CITY OF CONWAY, ARKANSAS HISTORIC DISTRICT COMMISSION

HISTORIC DISTRICT COMMISSION

March 28, 2022

I. Public Hearing Items - Old Conway Design Overlay District

North Elevation

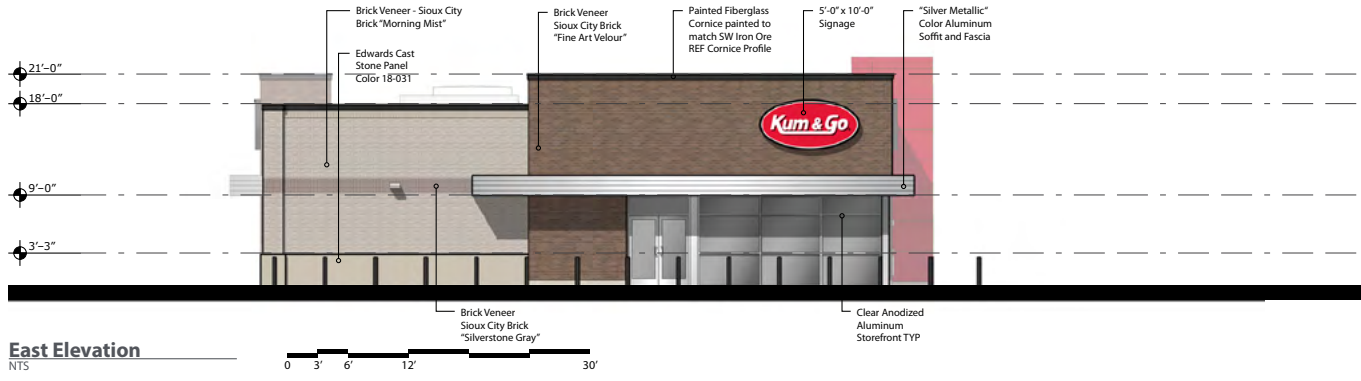
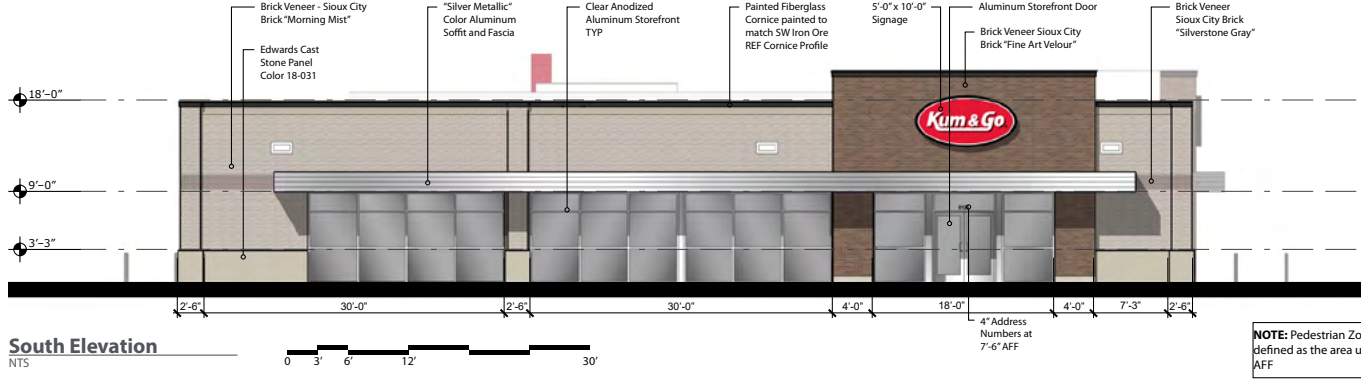
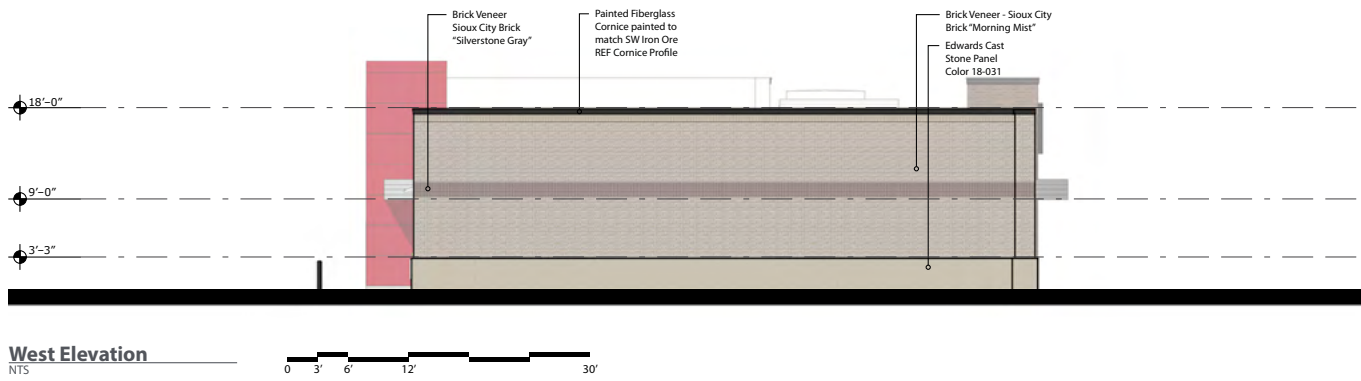
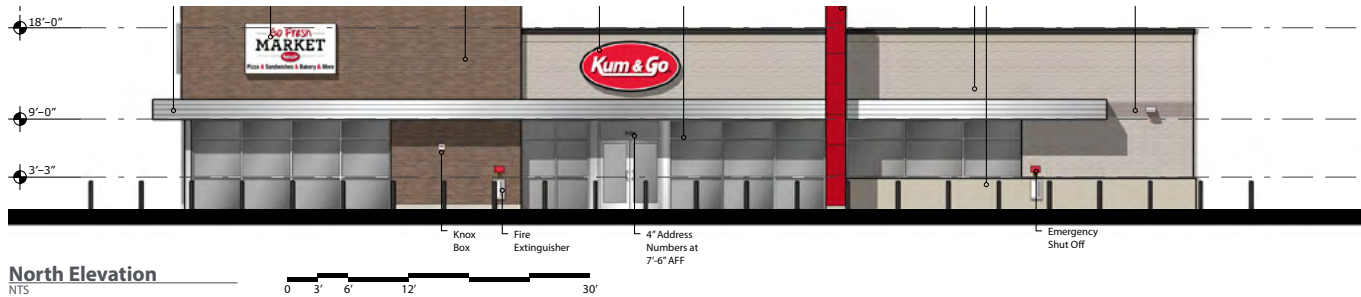
Staff interprets this provision as primarily toward façades facing a street or sidewalk. The Oak St facing façade is proposed to contain 32% windows instead of the required 66%. The Lincoln St façade is proposed to contain 0% windows instead of the required 66%. The Ingram St façade is proposed to contain 21% windows instead of the required 66%. While not fully meeting the requirements, the applicant has made good-faith effort to meet requirements in an appropriate manner. Staff considers the proposed inclusion of windows to be appropriate.

The proposed development will appropriately meet the requirements. Recommend requiring glazing along the Oak St façade remain transparent and include elements behind the glazing to provide visual interest.

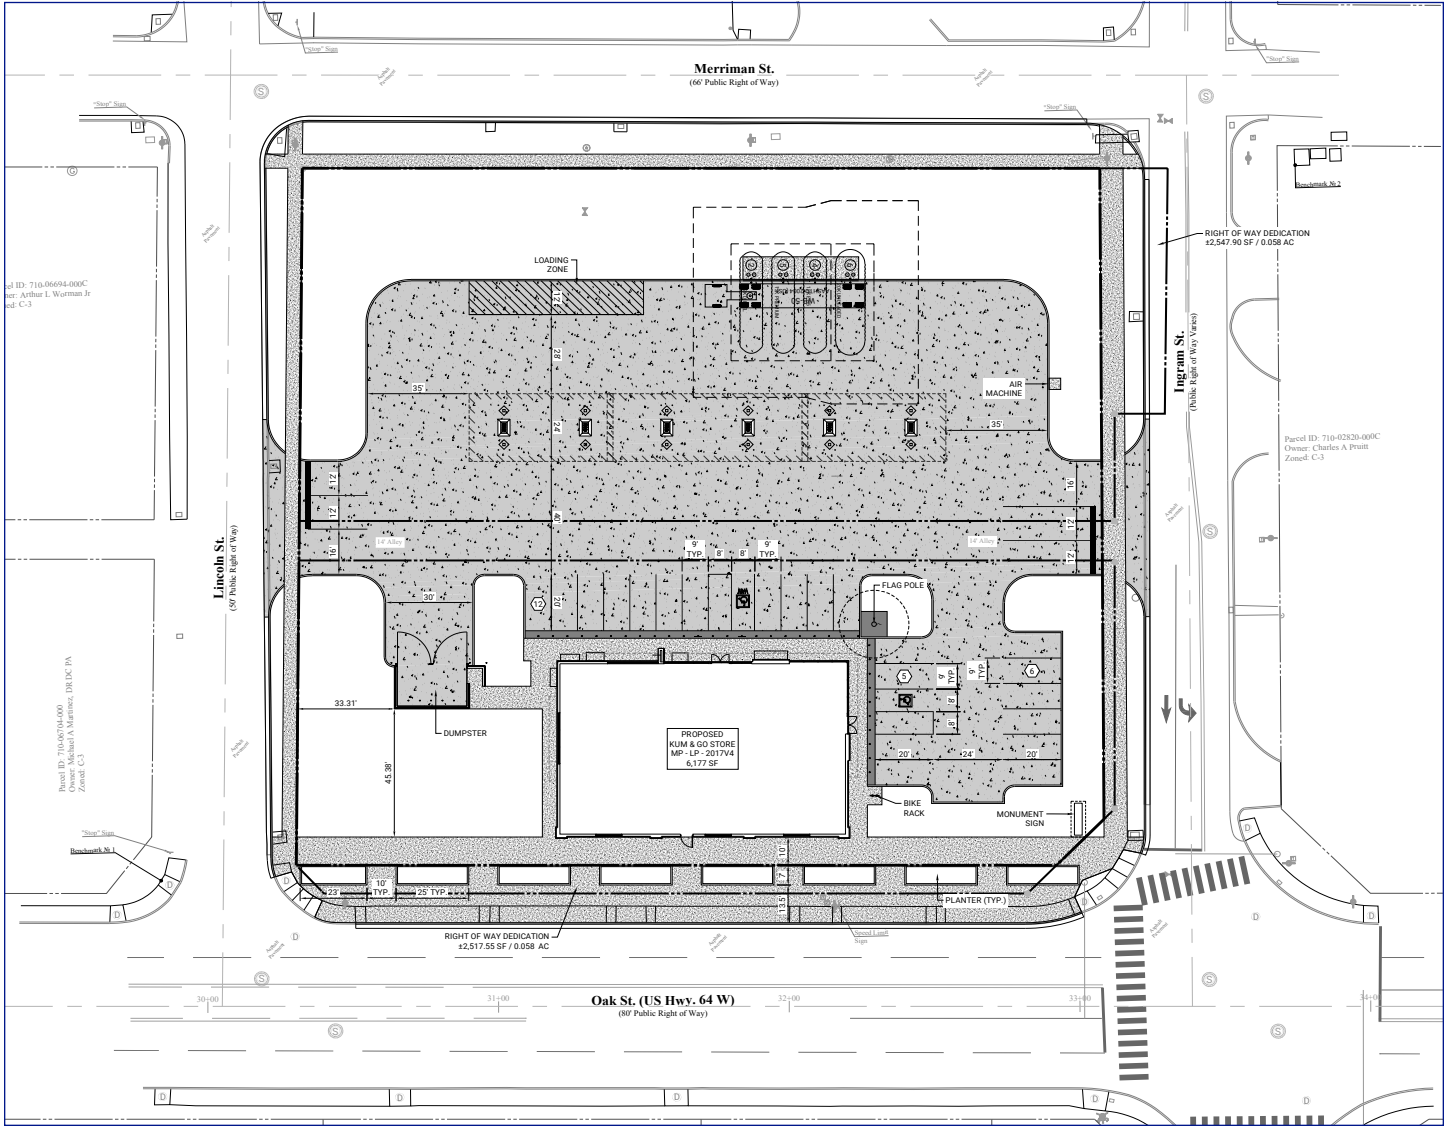
Though larger than permitted within the district, the signage is appropriate to the site. Recommend allowing an additional “art object” signage along the Lincoln St and Oak St intersection similar to the image to the right. Exact placement of ground mounted signage and “art object” shall be determined as part of the sign permit process.

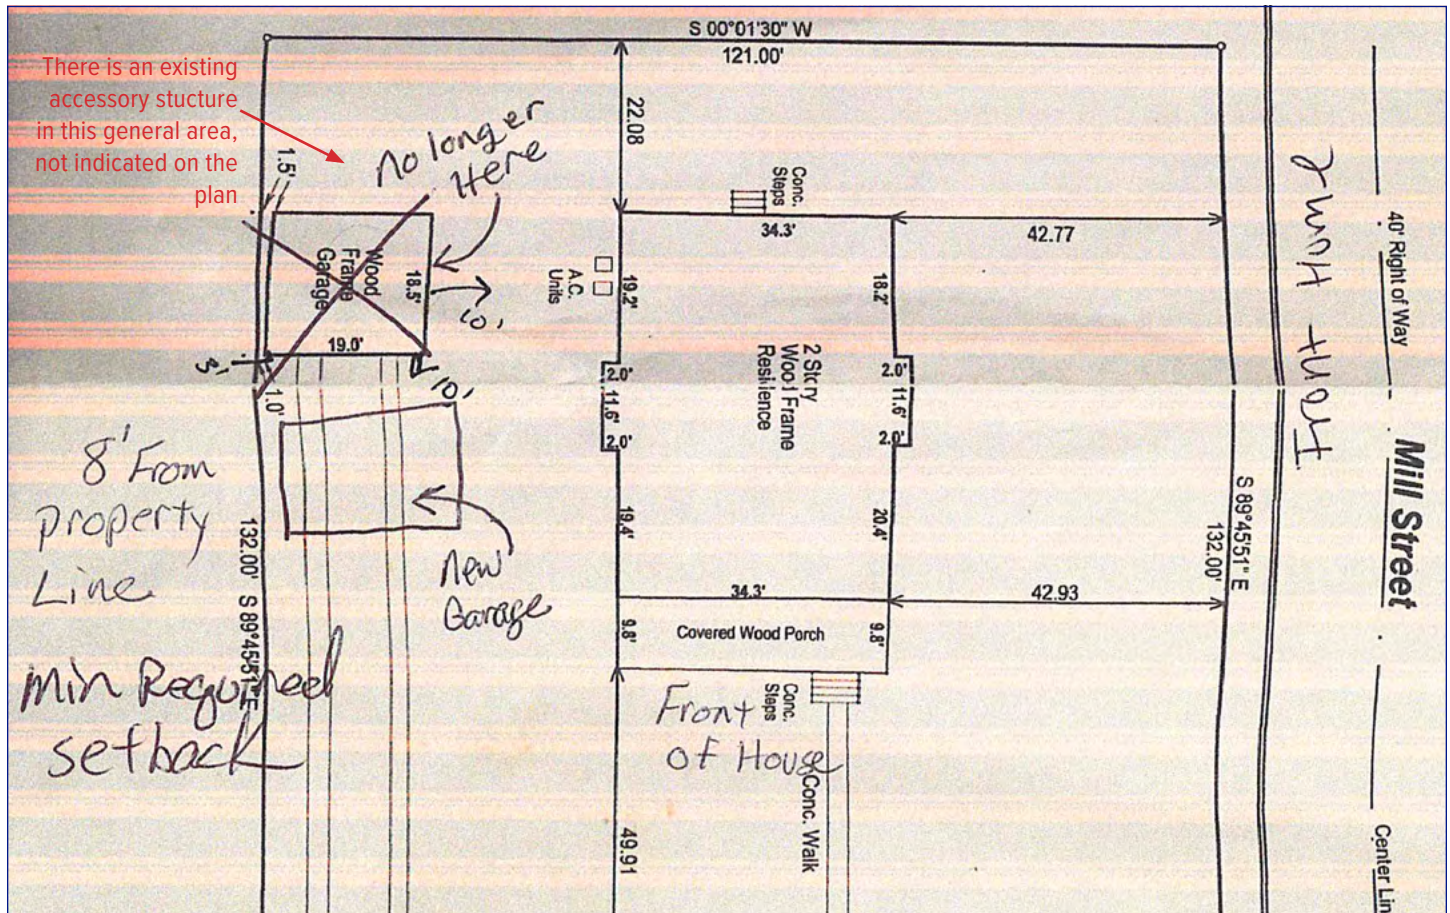
The structure is proposed to be in the side yard 8' from the southern property line. It is unclear where the applicant intends to set the structure as it relates to the front setback line. This will need to be clarified.

Rear Elevation

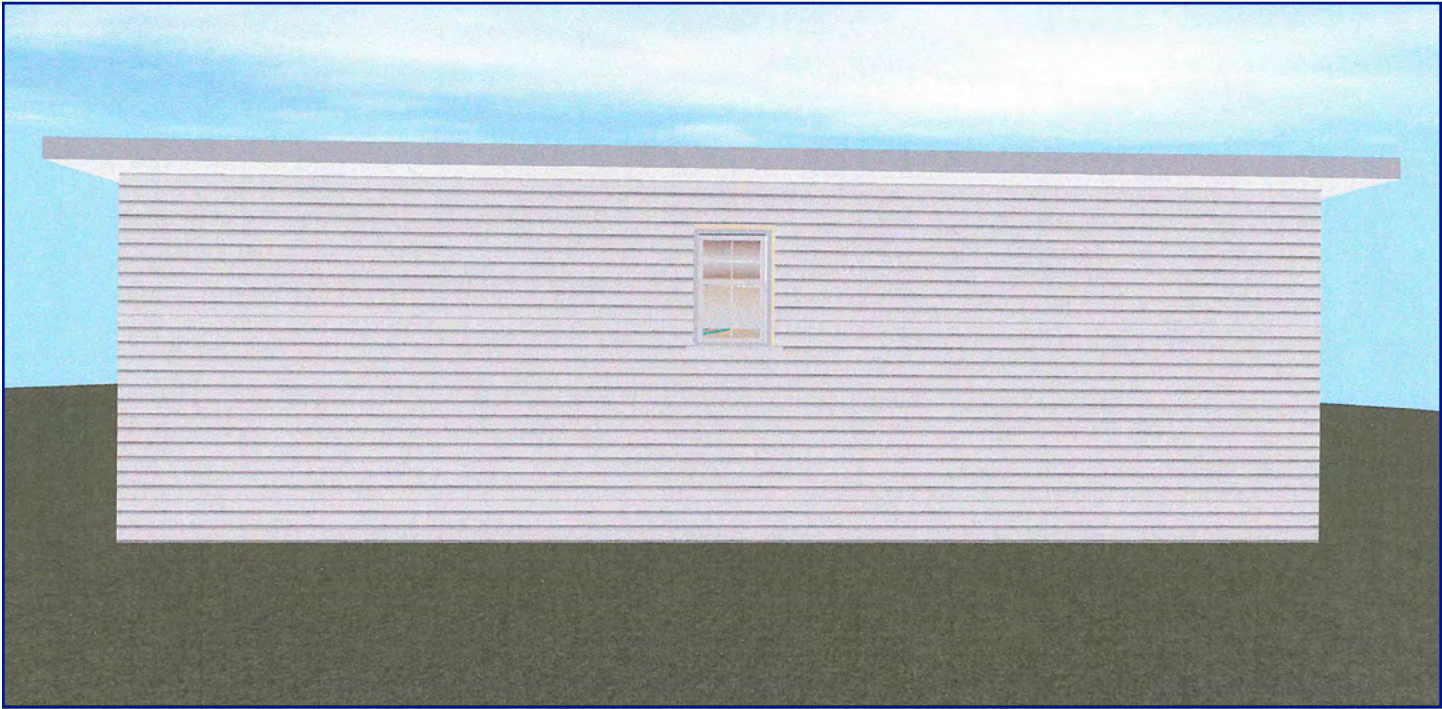
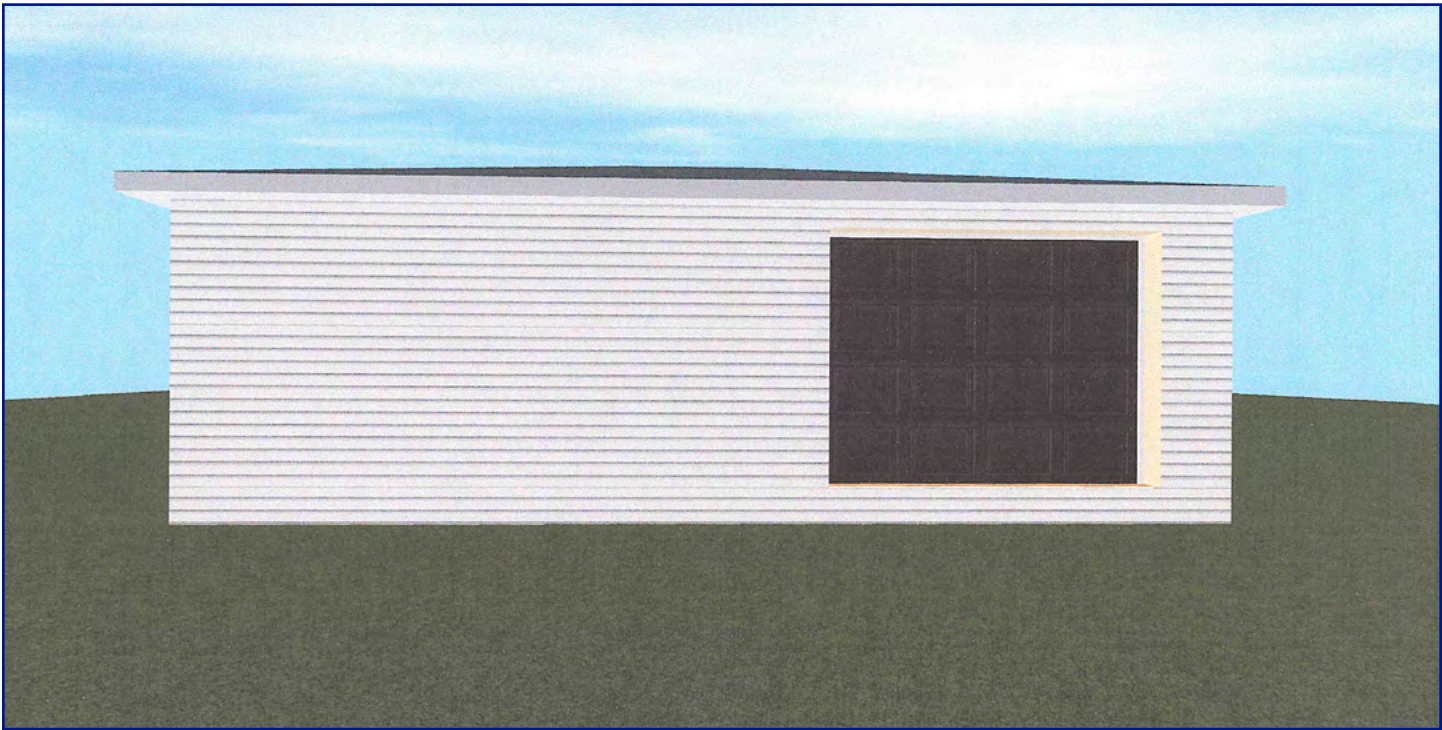
The proposed roofing slopes for the garage is 4/12 and will not match the house. Recommend requiring the roof match the pitch of the house.

The applicant is proposing Hardie® siding for the garage. This material is appropriate. A wood equivalent product such as LP SmartSide® is also appropriate. The structure has limited windows and will feature a large blank wall. Recommend requiring two windows in comparable size to the two upper-story windows on the front façade of the primary structure.

1. Require the existing accessory structure, if not placed on a permanent foundation, be moved to a different location on-site (in compliance with all codes and regulations, and place the new garage at the end of the existing driveway.

2. The roof-pitch for the structure shall match that of the house.
3. Require two additional windows in comparable size to the two upper-story windows on the front façade of the primary structure.
